Mapleton City Planning Commission Staff Report

Item: 3
Applicant: Dave Helm, Ponderosa Property
Location: 700 N and Main St.
Prepared by: Brian Tucker, Planner
Public Hearing Item: Yes
Zone: RA-2

Consideration of Preliminary and Final Plat approvals for the *Ponderosa* Subdivision consisting of twenty four lots located at approximately 700 North Main Street in the Residential Minor-Agricultural (RA-2) zone.

MAPLETON CITY DEVELOPMENT REVIEW COMMITTEE MINUTES

PLAT "A"

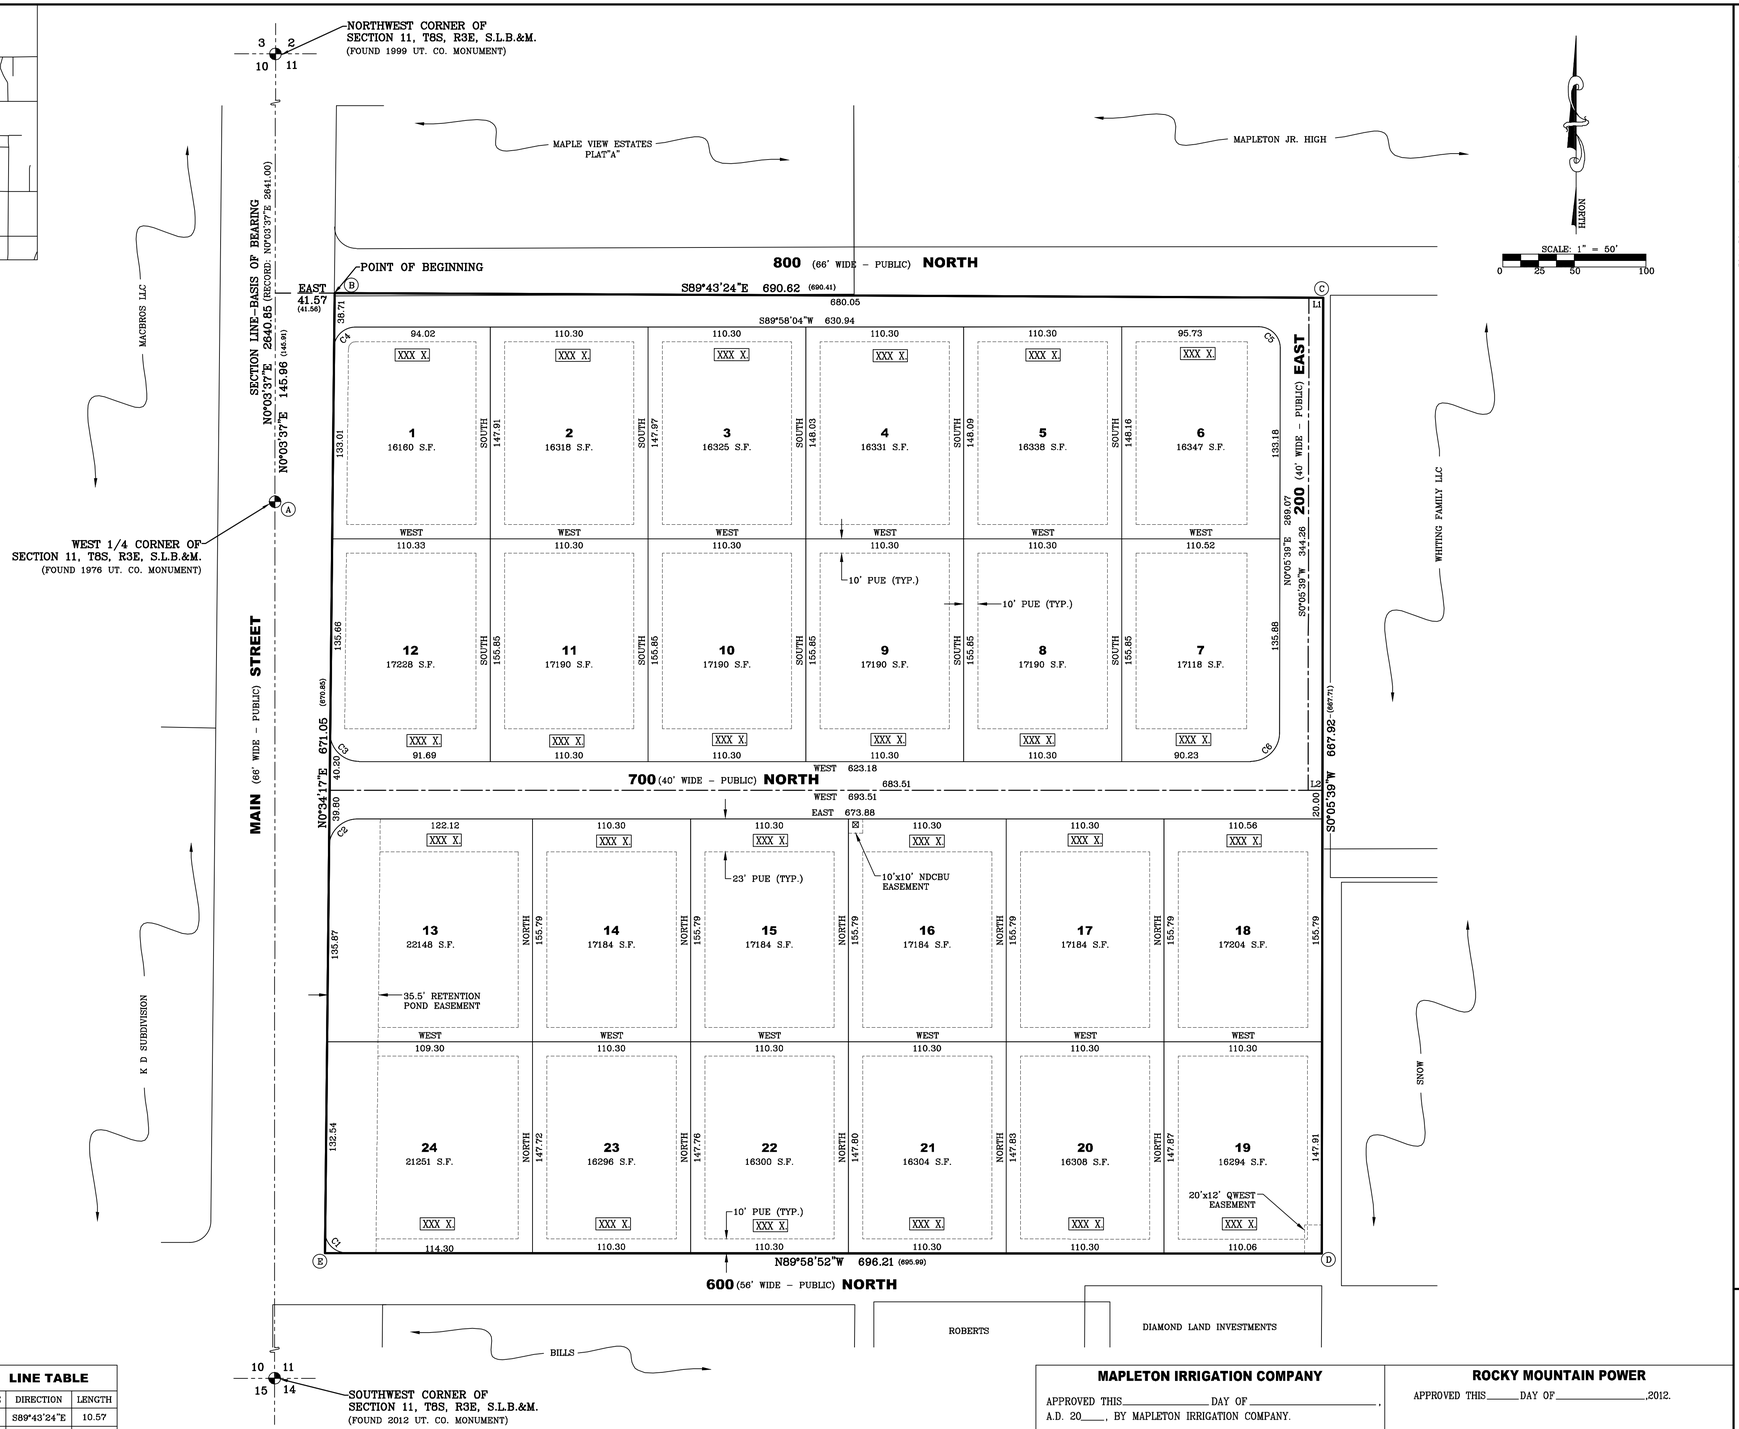
2. The existing irrigation ditch must be piped. The plans must be submitted to and approved by Mapleton Irrigation.
3. The Notary Acknowledgement signature blocks don't need a "Notary Address" line but they do need a line for the "Commission Number".

4. A "Community Development Approval" signature block is not needed. The "Planning Commission Approval" block should have a line that reads "Community Development Director" rather than "Planning Director"

Miscellaneous:
1. Receive irrigation company approval for work on Mapleton Irrigation Company ditches
2. Plat Modifications:
    a. Lot #19, show 10' PUE beyond existing utilities.
    b. Lots #1 and 12, show irrigation easement and 10'PUE east of irrigation easement.
    c. Lots # 13 & 24, Show PUE with storm drain basin easement.
3. Show power pole relocations.
4. Mapleton City/APWA standards will apply.

600 NORTH PLAN & PROFILE

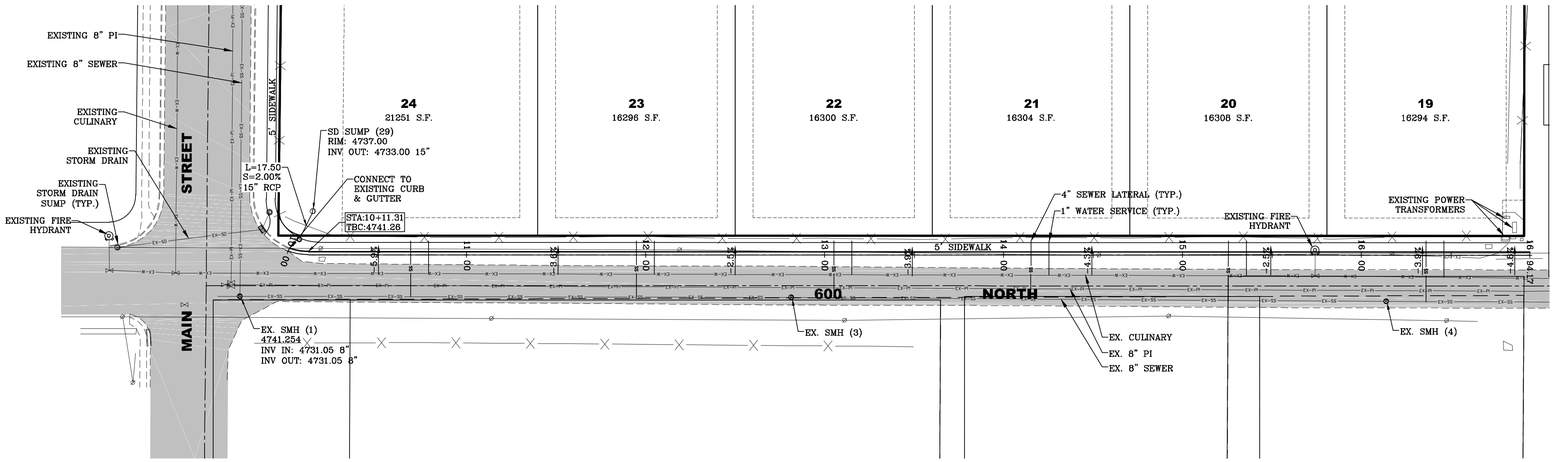
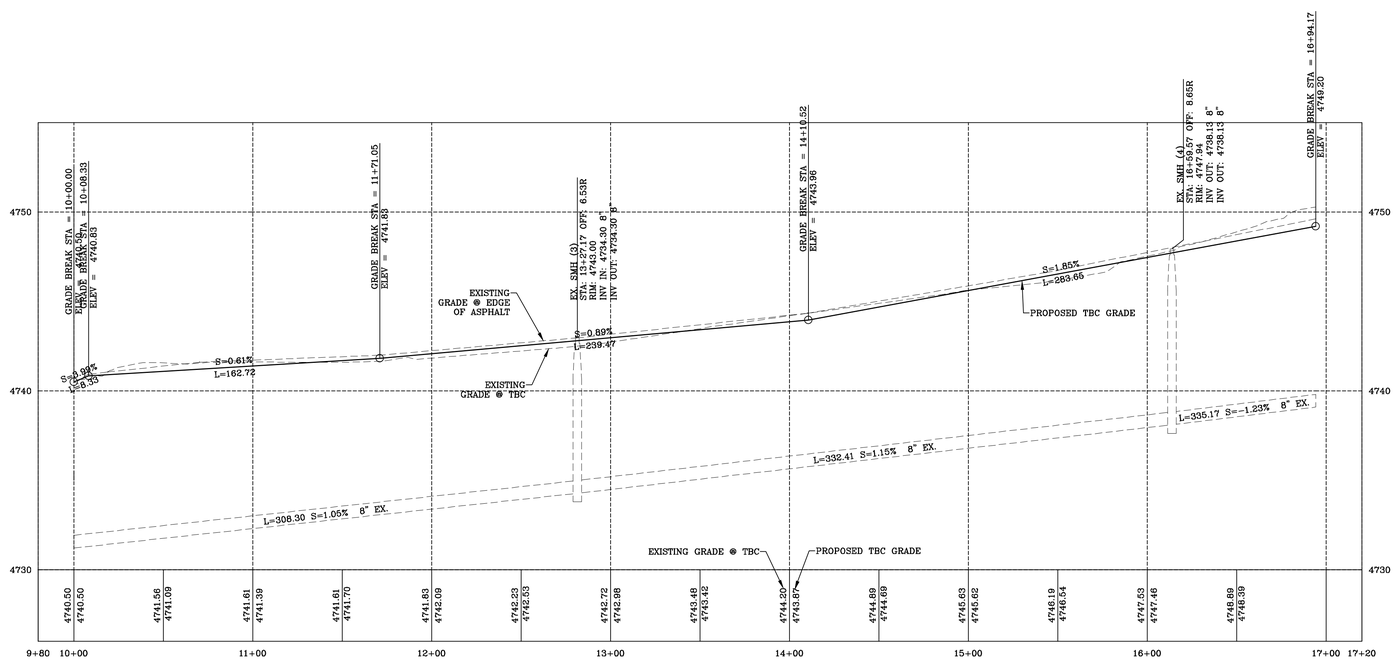
Roadway:
1. Road x-sections
    a. Transportation Master Plan calls for 600 and 800 North to be 56' R/W, 200 East and 700 North can be 40' R/W standard.
    b. 600 North half street improvements will begin at centerline of existing roadway.
    c. 700 East will be full width paving with curb and gutter on east edge, the developer can request reimbursement for these improvements.
2. Show ADA ramps at all corners.
